Engineering Change Notice

The following table contains a list of engineering changes that are not reflected in the Tsi381 Evaluation Board Schematics.

Tsi381 Evaluation Board Schematic

TSI381 PCIE/MISC INTERFACE

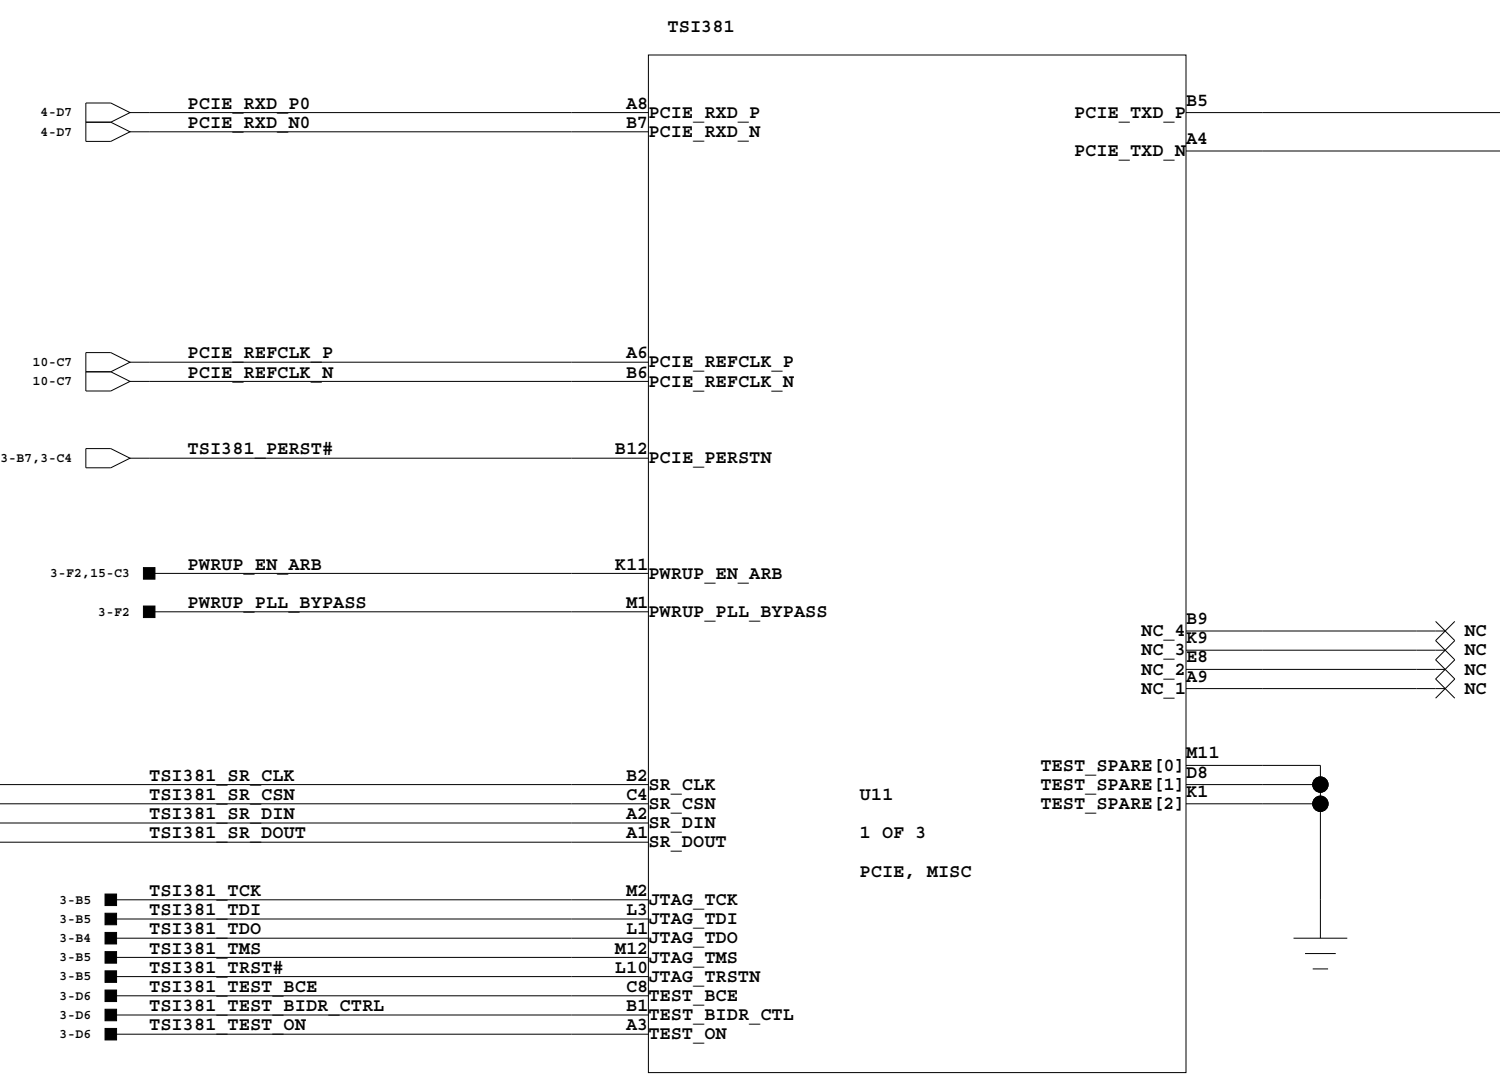
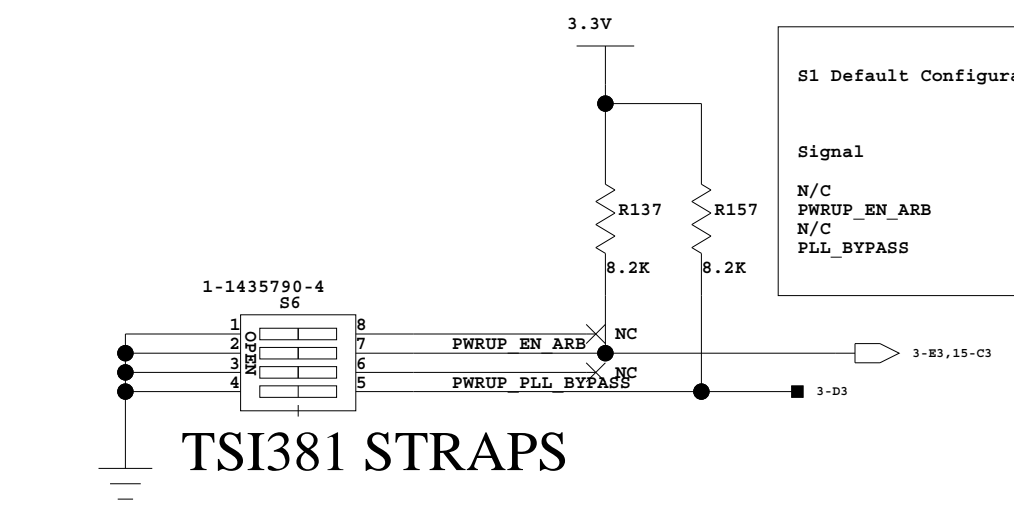
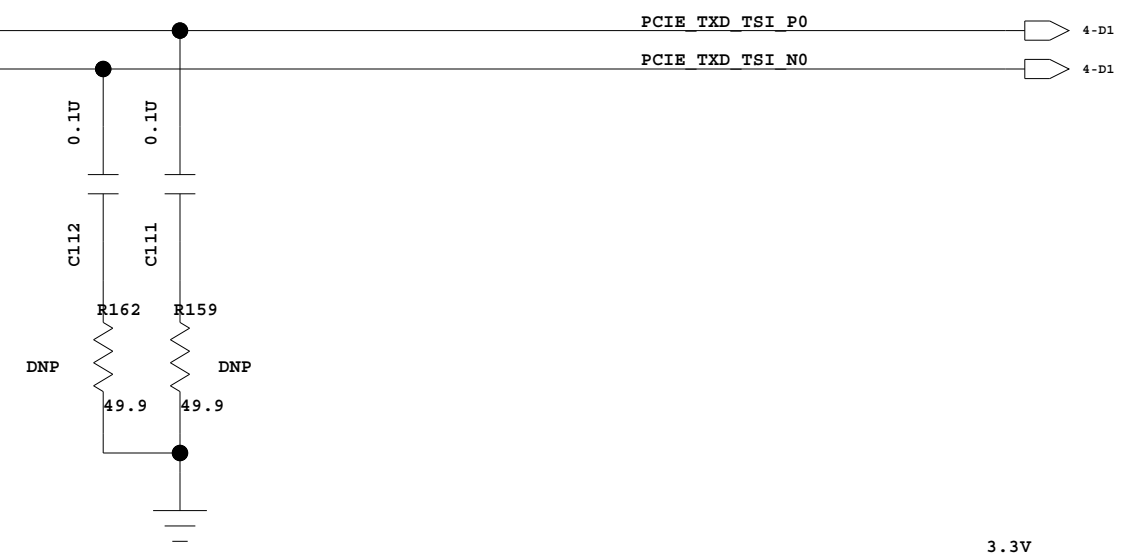
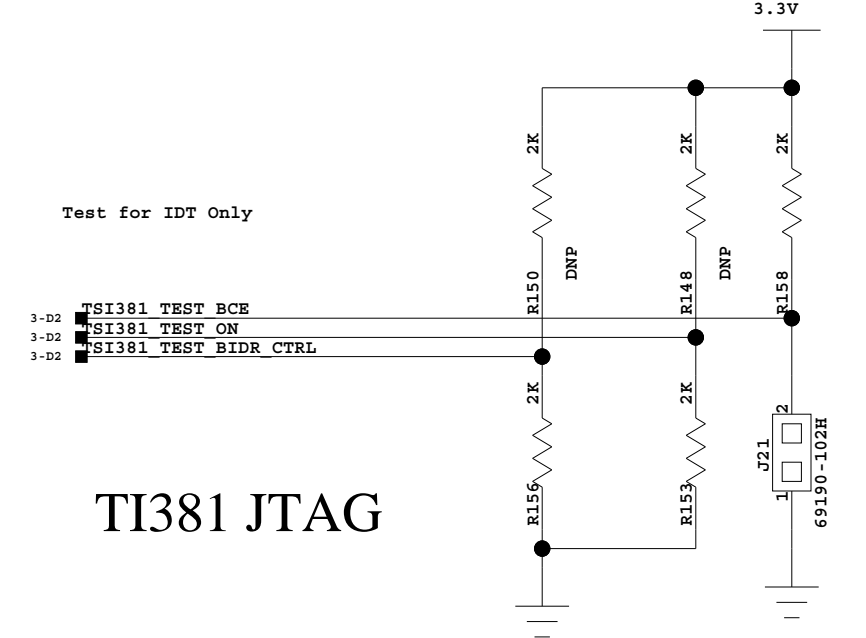
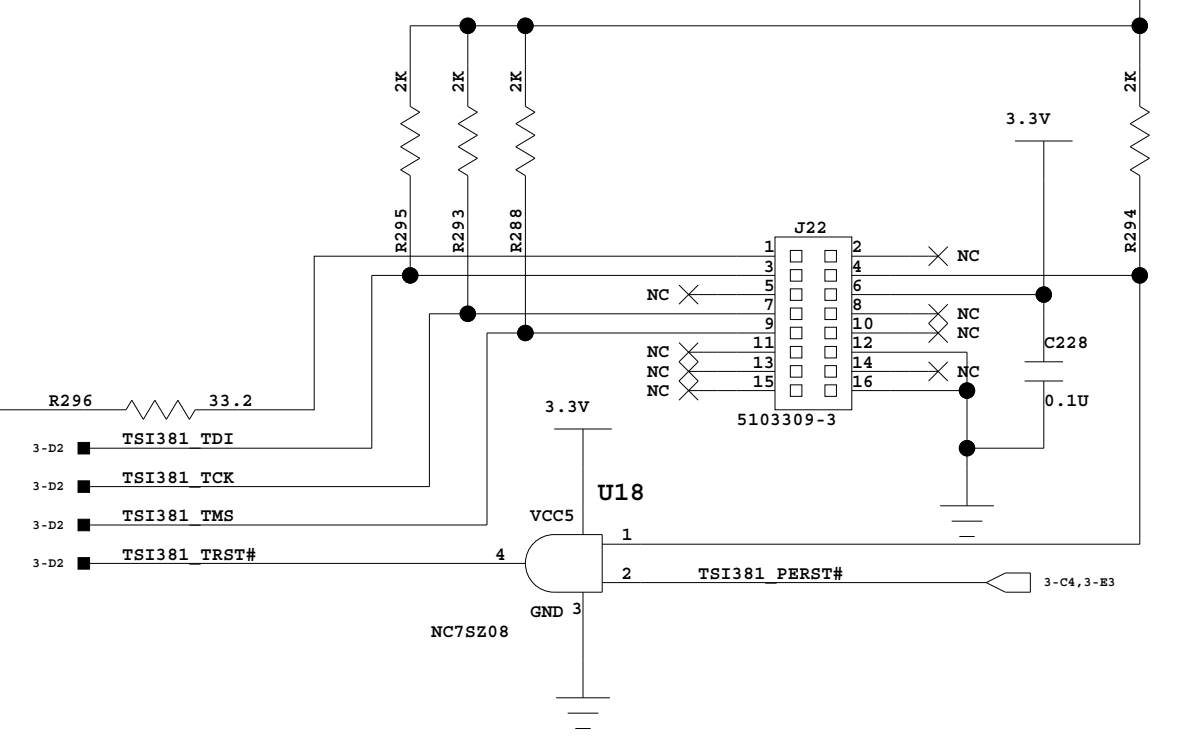
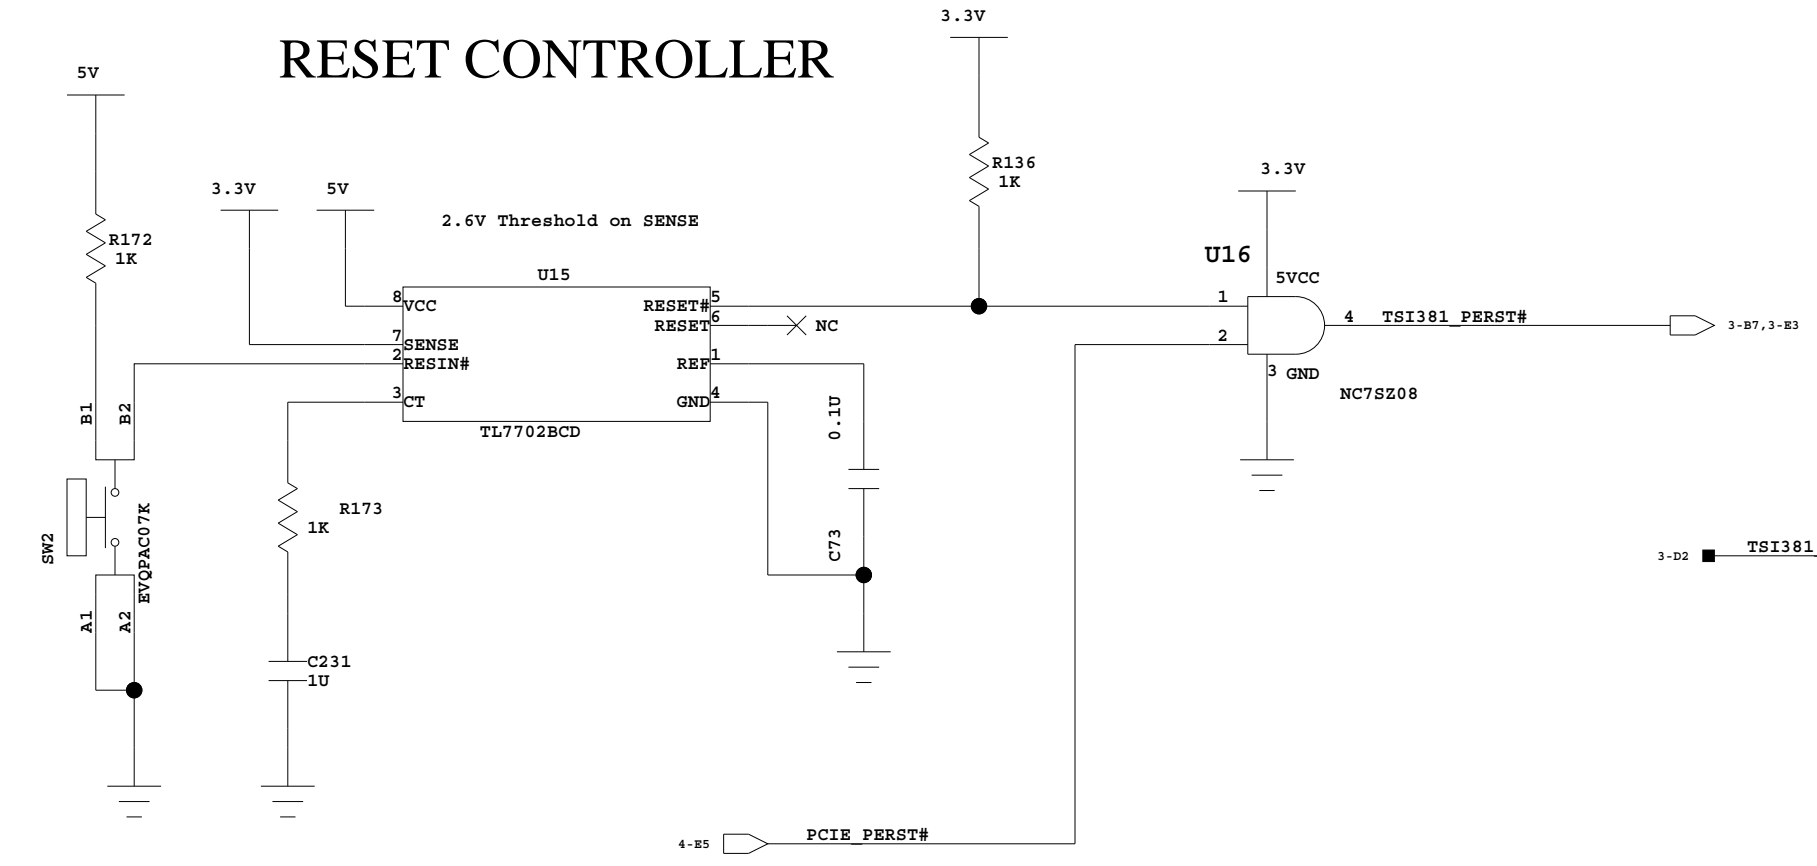
No.	Item(s)	Original	Change To
1	Tsi381 Device	Tsi381-66ILZ1	Tsi381-66ILZ2
2	3.3Vaux on J1, J2, J36, J37 ^a	No connection	Short pin A14 (3.3Vaux) to pin A16 (VIO_PCI) with 0-Ohm (0603) resistor

No.	Item(s)	Original	Change To
1	Tsi381 Device	Tsi381-66ILZ1	Tsi381-66ILZ2 ^a
2	3.3Vaux on J1, J2, J36, J37 ^b	No connection	Short pin A14 (3.3Vaux) to pin A16 (VIO_PCI) with 0-Ohm (0603) resistor

a. Ball K1 was removed from the Tsi381 device to allow the TEST_SPARE[2] signal to be detected as logic high. This version of the evaluation board is intended to support applications that require PCI bus parking on the Tsi381.
